Requests to be Heard

Planning and Amenity
Delegated Committee Meeting

13 February 2024 Planning and Amenity Delegated Committee Meeting

Proposed Additional Condition of Permit

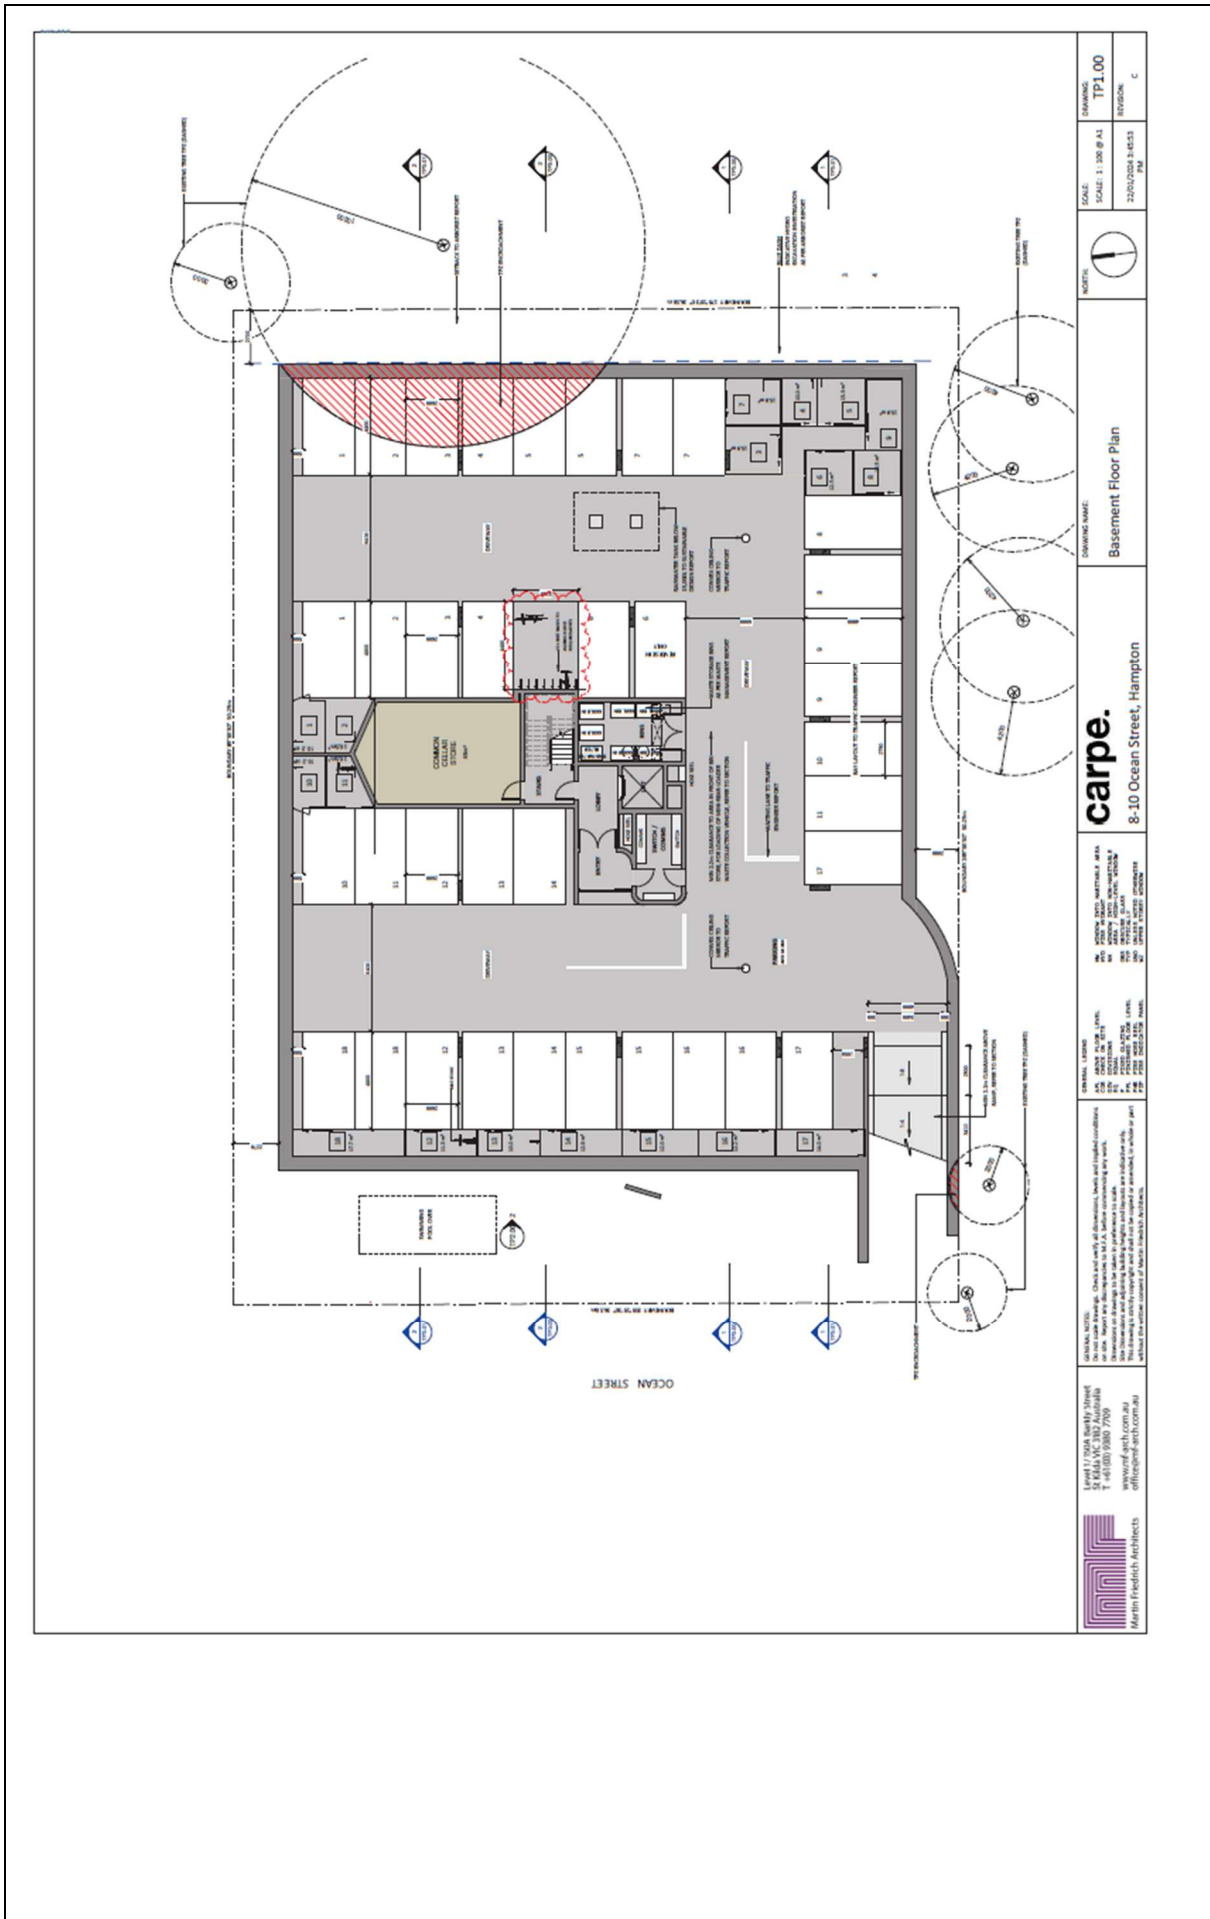
2.	Mr Tony Shepherd (on behalf of Hampton Neighbourhood Association)	(O)
<p>Committee Chair, Mayor, Councillors</p> <p>In the event that councillors are minded to grant a permit to this application, HNA urges insertion of a condition of permit, to bring the application back into line with mandatory height requirements</p> <p>Should councillors not wish to insert such a condition, HNA urges refusal of a permit.</p> <p>The proposal in front of councillors is for a three storey apartment block plus rooftop deck in a zone where a maximum height control applies. In such locations DDO12 is clear in stating that roof decks and their associated structures must not exceed Maximum Building Heights.</p> <p>However, in this case, a number of roof deck structural elements, including walling and the access stairwell breach mandatory height requirements. Exceedence is minor, being in the region of 300-500mm, and so is something that will be easy for the applicant to correct.</p> <p>However, rather than direct the applicant to comply with maximum height requirements, the officer's report recommends exercise of discretion. Arguments in support of this are presented on pages 32 to 33 of Council's agenda papers.</p> <p>In HNA's opinion the case presented is unconvincing, drawing on two VCAT decisions which are respectively 8 and 11 years old, extracts of which are presented out of context and in an incoherent manner.</p> <p>For Council to decide to exercise discretion with respect to mandatory height requirements represents a major policy shift, with significant ramifications for all future apartment block applications across Bayside.</p> <p>Such a policy shift is a matter which councillors would be expected to consider only upon receipt of a detailed study after a consultation process.</p>

HNA therefore urges councillors to reject this ill-considered implicit rewriting of Bayside's Planning Scheme, either by inserting a condition of permit requiring compliance with mandatory height requirements or by refusal of permit.

- 1. k)** All rooftop deck structural elements (walling, access stairways etc) to be constructed to comply with Maximum Building Height requirements, as specified in Schedule 12 to the Design and Development Overlay for Bayside.

Figure 1 significant non-compliance with the Planning Scheme Standard for side setbacks

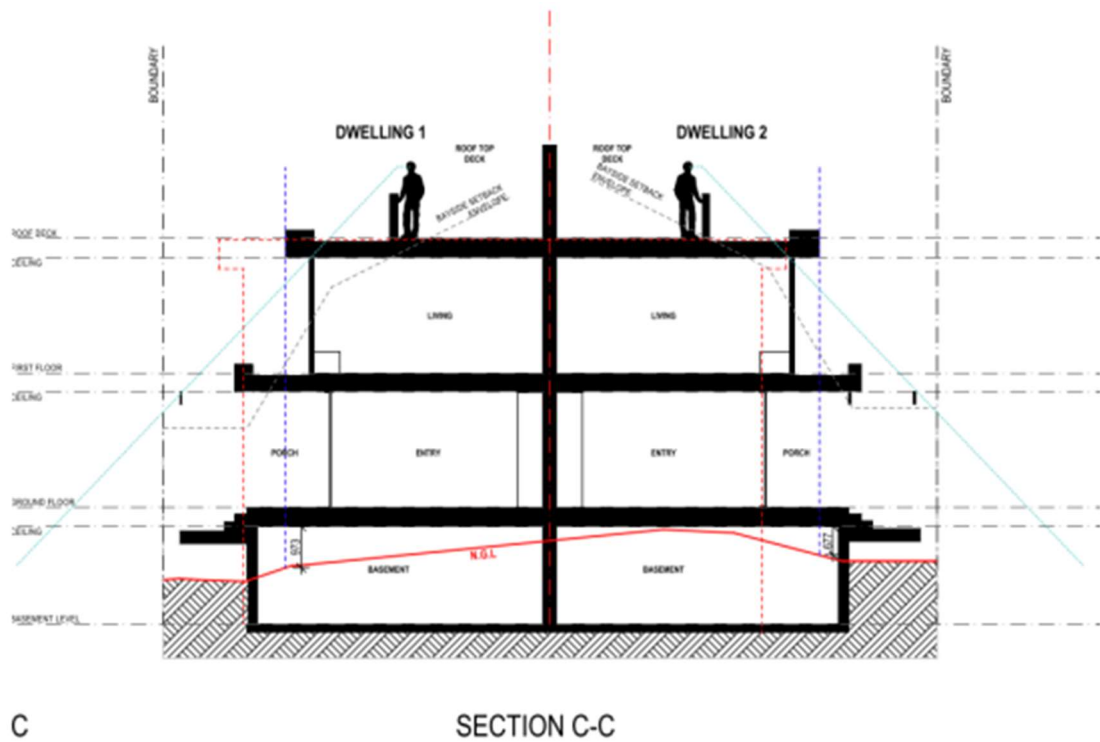
There is a series of non-compliances with setbacks from side and rear boundaries as indicated by the documentation provided by the permit applicant.

The non-conformity with the provisions of the planning scheme with regard to setbacks is significant and clearly indicates that there is overdevelopment of the site.

Figure 3 the purple line indicates the required setback under the Standard

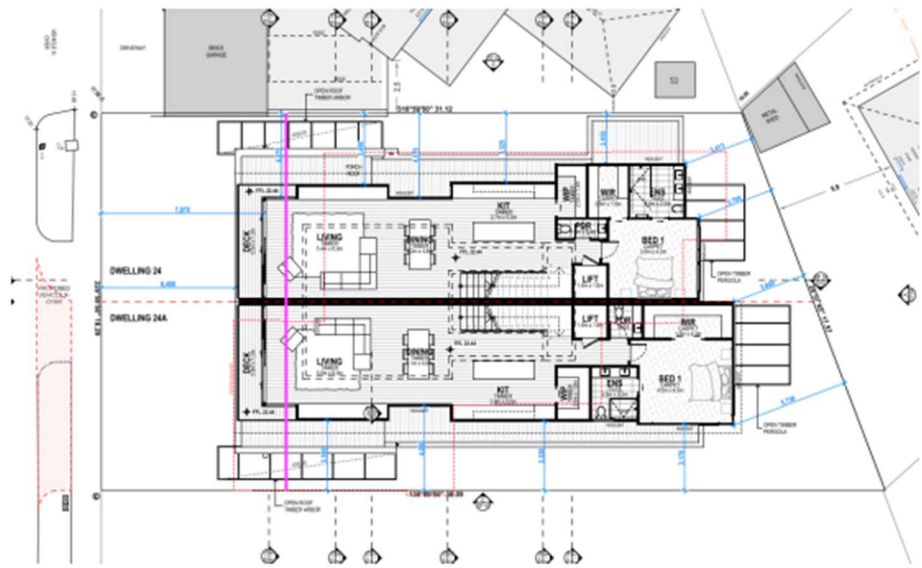
There is also non-compliance with the front setback and this issue is of particular concern to our clients because it involves a major intrusion into the outlook from their main living area as indicated in the following images.
